MANDATORY BULLETIN

Number: ZB SD4-04-2013

Name/Subject: Location of the sensing of the static pressure inside the rear of the fuselage

Models affected: Viper SD-4 aircraft with serial numbers:
003, 006, from 010 to 012 inclusive, 014, 015, from 017 to 019 inclusive,
022, 023, 025, 029

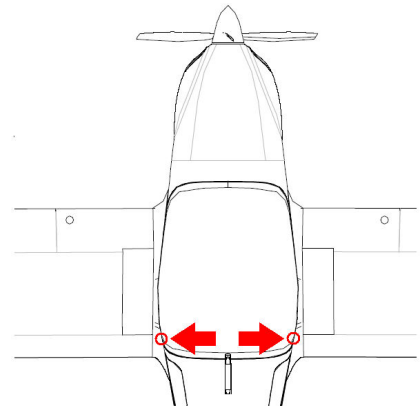
The original static pressure ports are located symmetrically on the sides of the fuselage, below the cockpit windows, as it is shown in the picture on the right.

The static pressure ports have a round shape and are riveted to the insides of the side fuselage skins in the upper part of the baggage area.

The static pressure ports are connected to plastic tubes $\text{Ø}6 \times 1$ mm, leading to the flight instruments located on the instrument panel. The tubes are secured on the static pressure ports by locking clips.

With the help of pliers remove the locking clips and disconnect both tubes from the static pressure ports.
